RE: Hydrogen Energy California Project  
Application for Certification 08-AFC-8

**Amendment to the  
Revised  
Application for Certification  
(08-AFC-8)  
for  
HYDROGEN ENERGY CALIFORNIA  
Kern County, California**

September 2009

**OVERALL BLOCK FLOW DIAGRAM**  
September 2009 Hydrogen Energy California (HECA)  
28067571 Kern County, California  
**URS**  
**REVISED FIGURE 2-3**

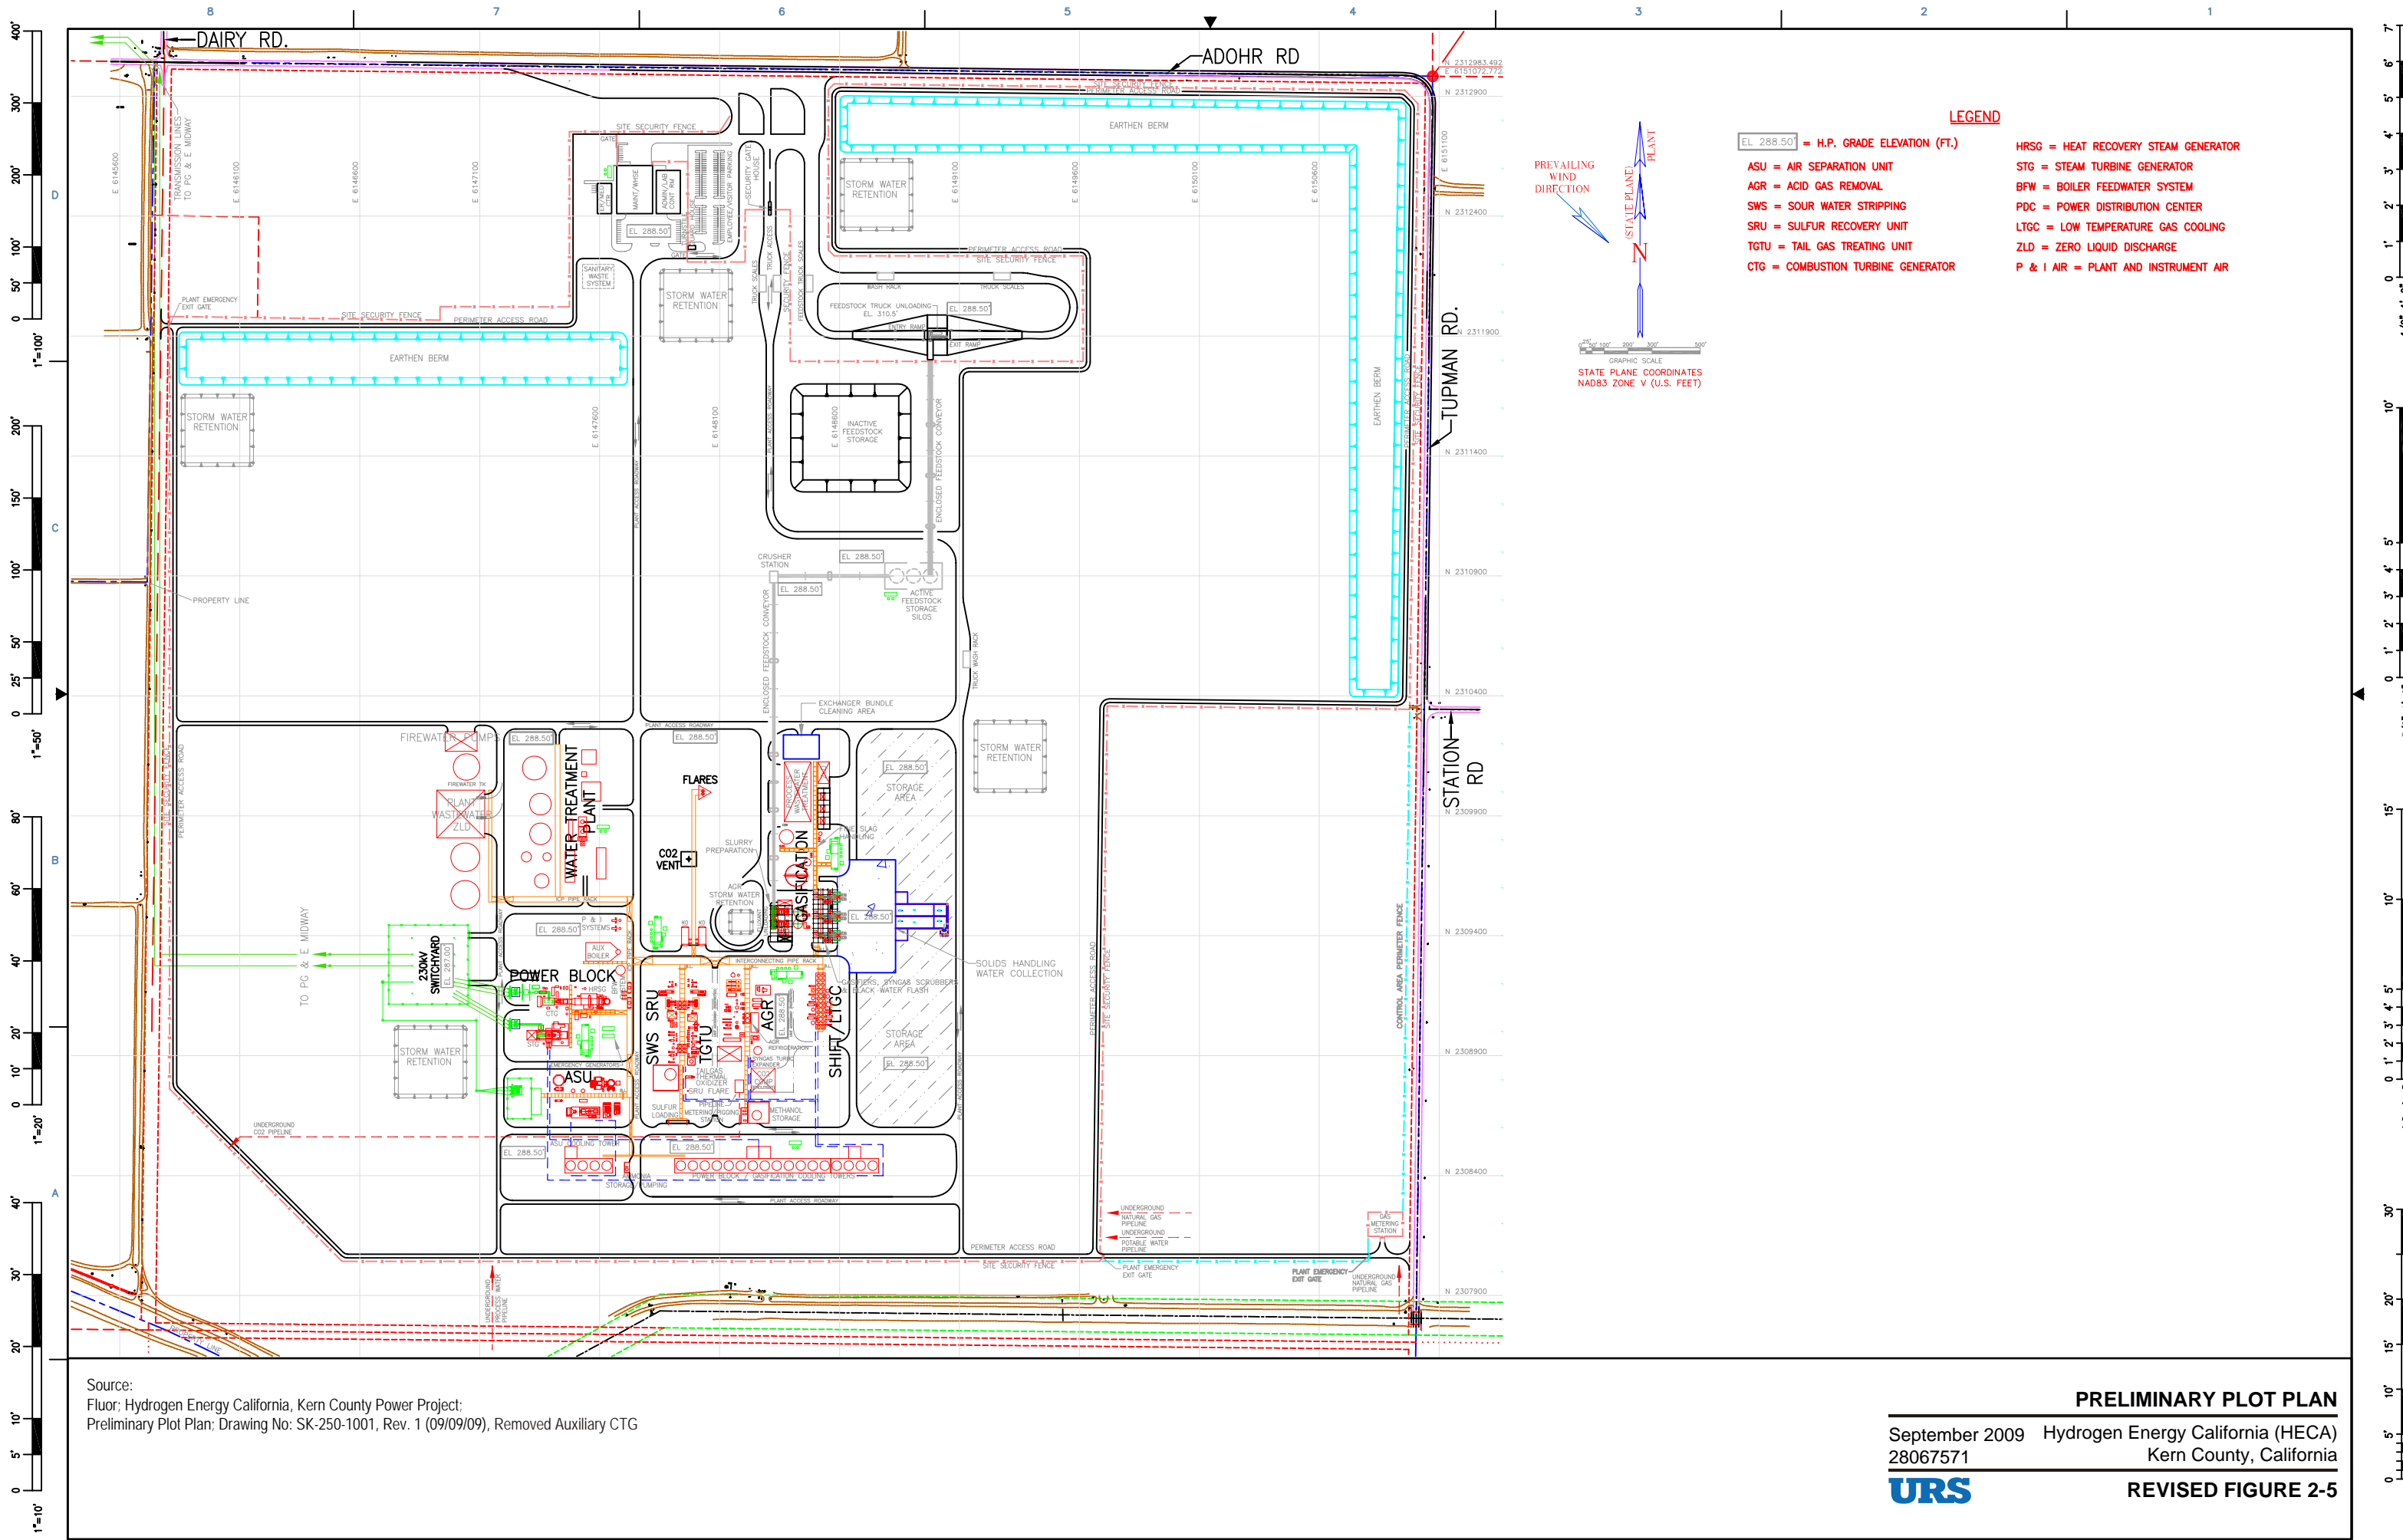
Source:  
Fluor; Hydrogen Energy California, Kern County Power Project;  
Block Flow Diagram; Drawing No: A3RW-BFD-25-001, Rev. 5 (09/09/09), Removed Auxiliary CTG

REVISED FIGURE 2-6

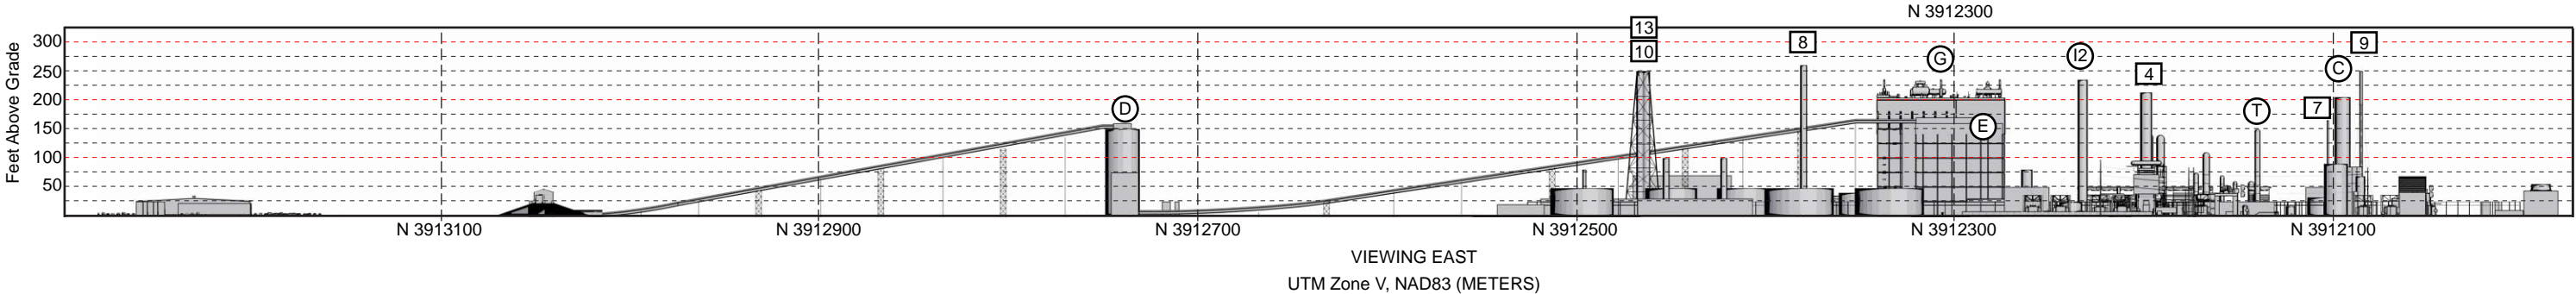
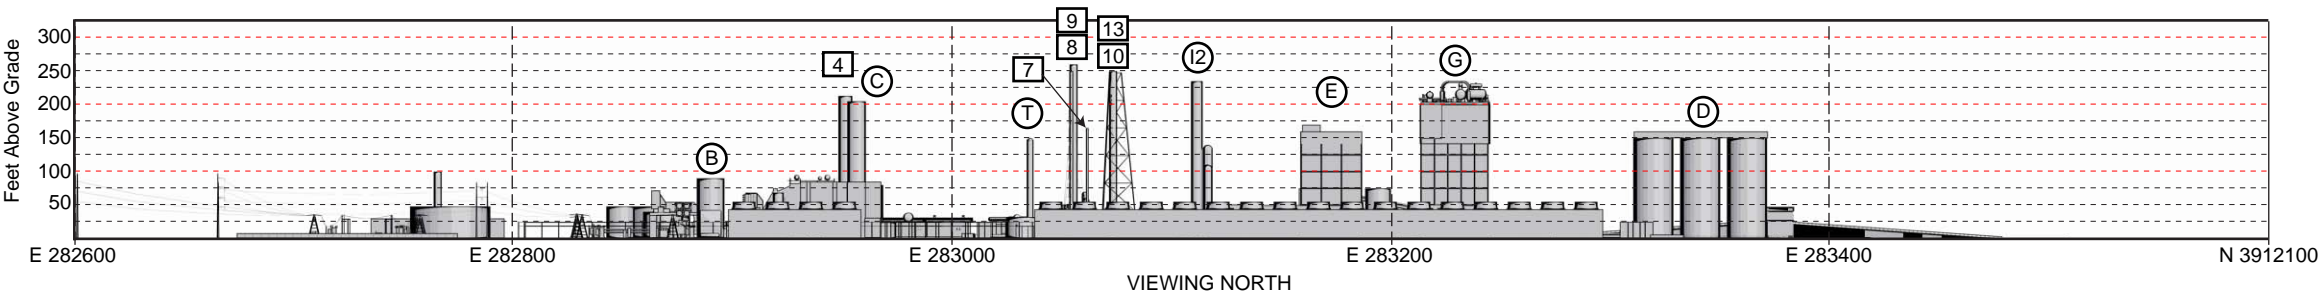
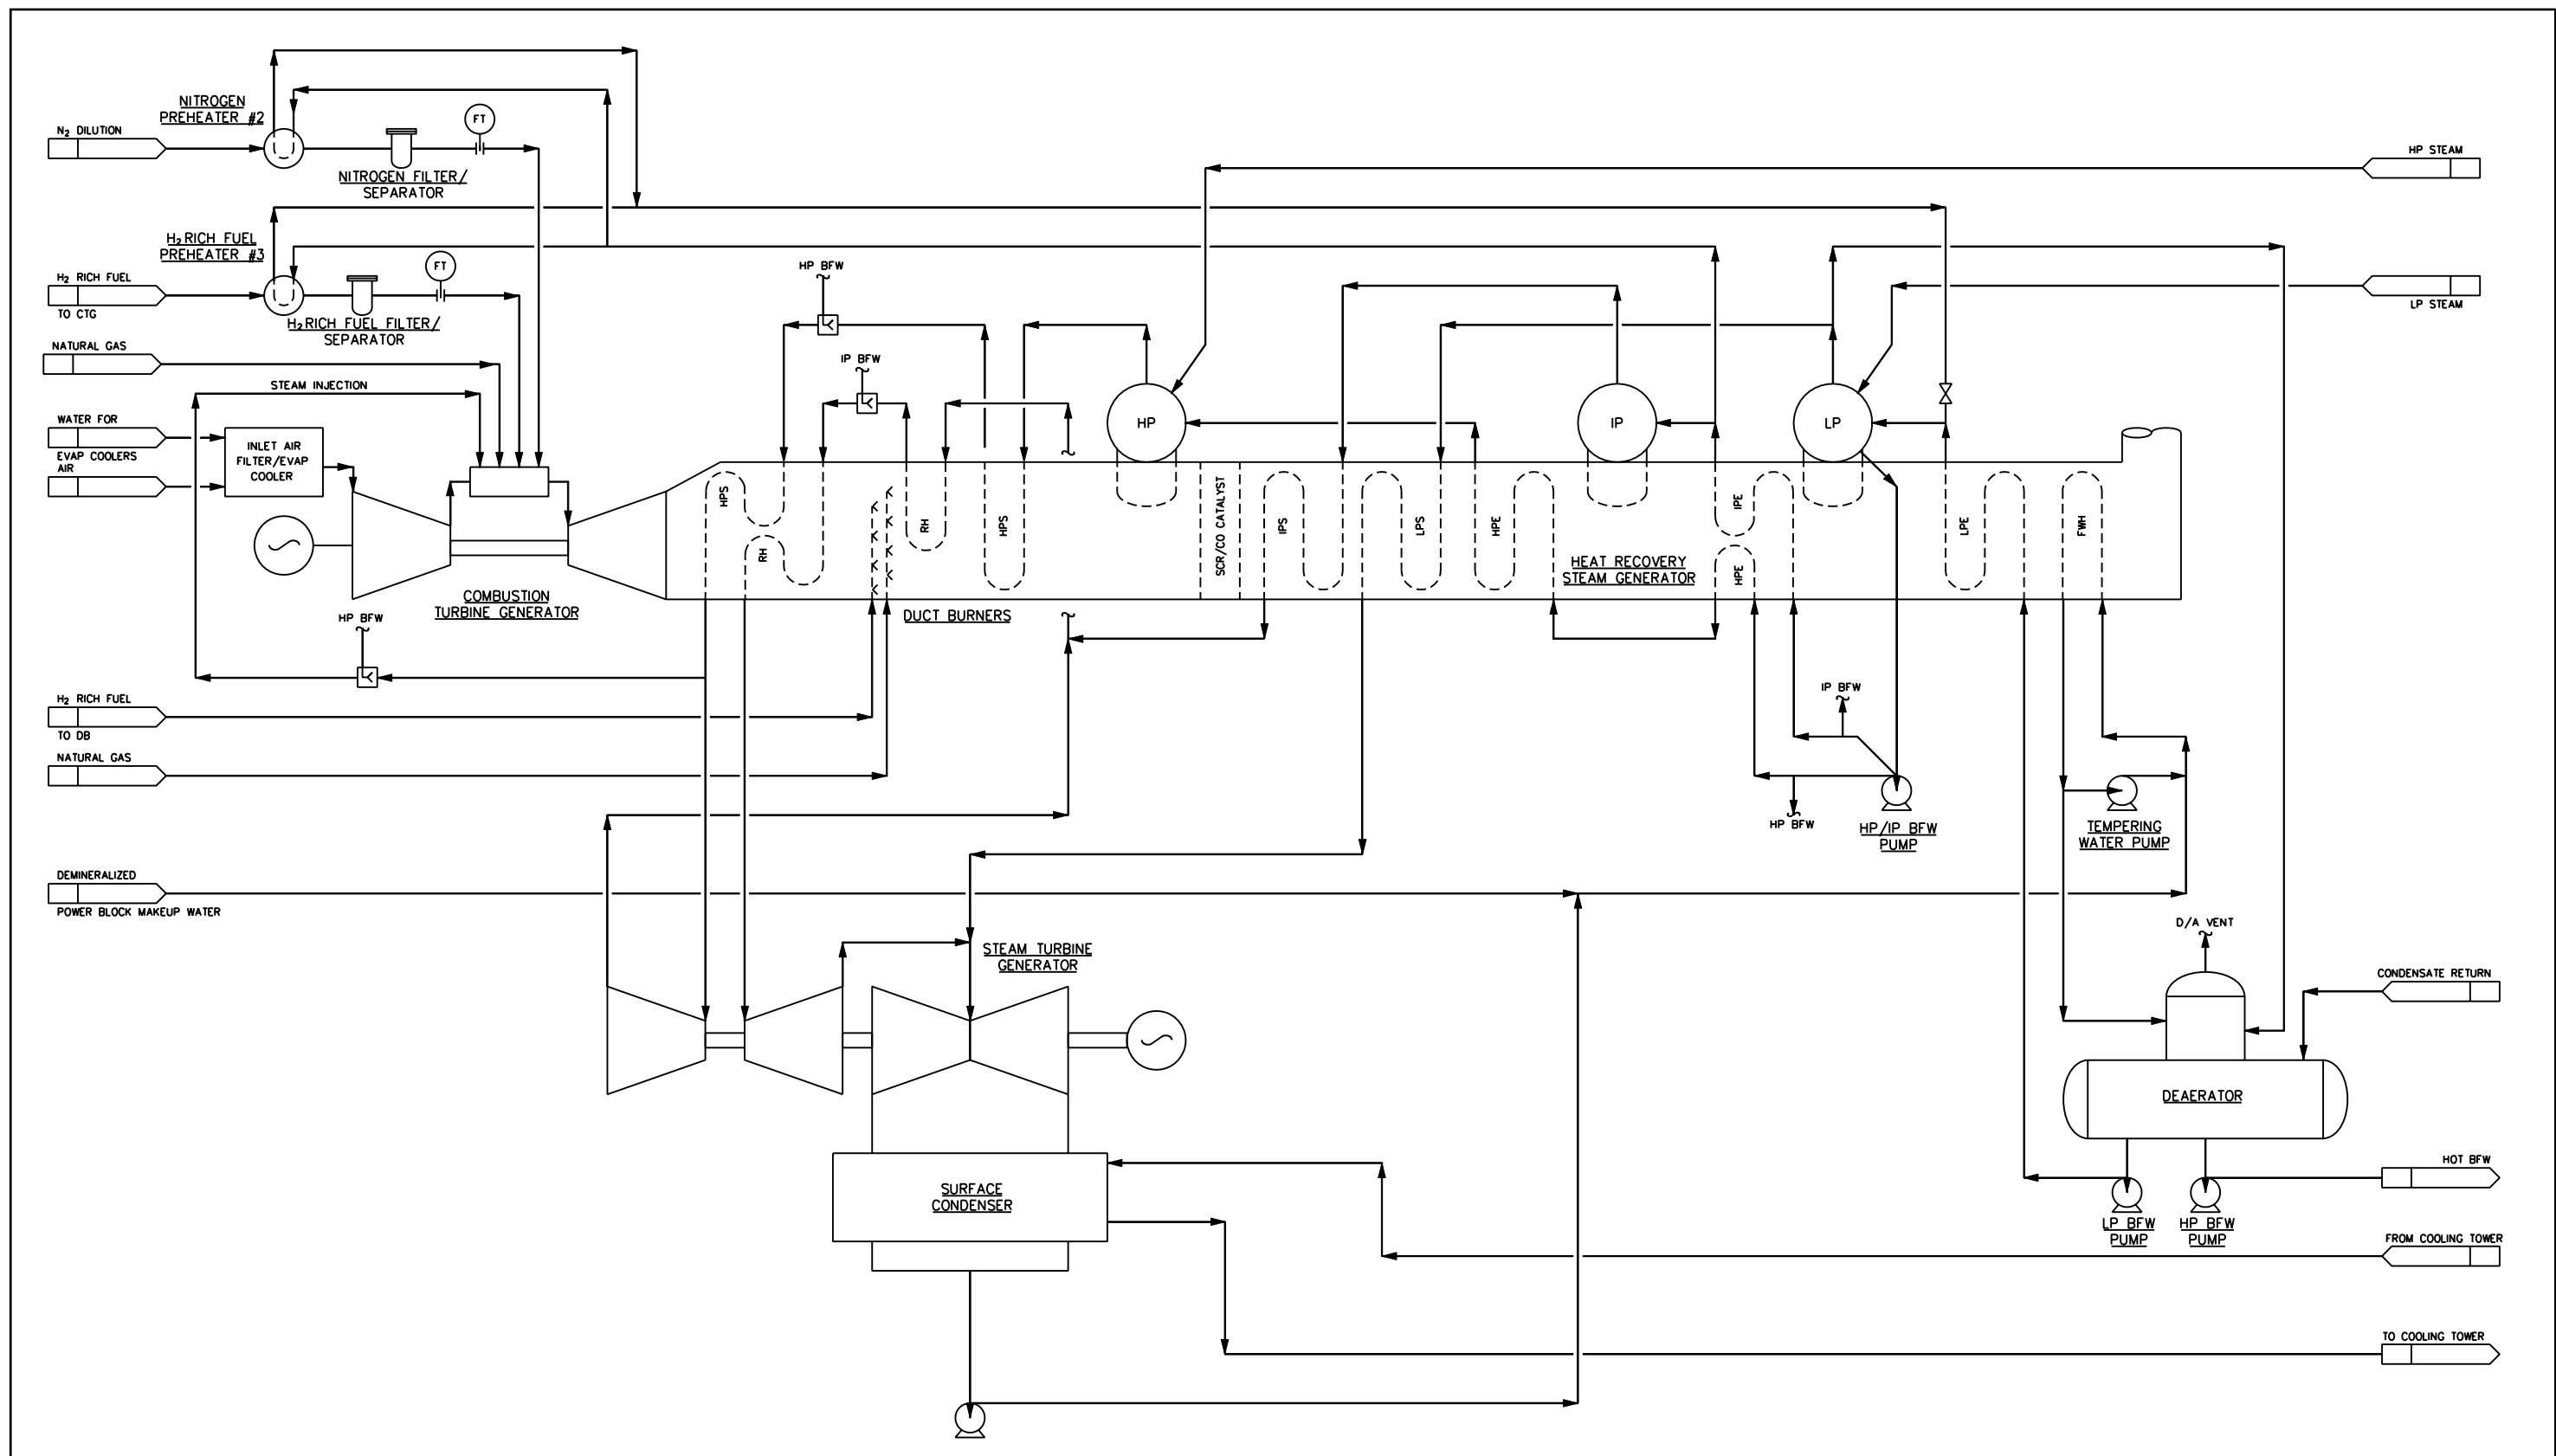
Changes to the above figures includes removal of equipment shown as Auxiliary CTG Structure and Auxiliary CTG Stack (identified as M2 and 12, respectively, on Figures 2-6 and 2-38) of the Revised AFC.

The Project modification consists of eliminating the auxiliary CTG within the 473-acre Project Site and would not result in the disturbance of areas not previously evaluated in the Revised AFC. Revised Figure 2-6 provides new elevation drawings incorporating the Project modification. This figure has been revised to delete the following equipment from the previous drawings: Auxiliary CTG Structure (previously identified as No. M2, with height of 45 feet) and the Auxiliary CTG Stack (previously identified as No. 12, with height of 110 feet).

(12)	DELETED	NA
(13)	RECTISOL FLARE	250
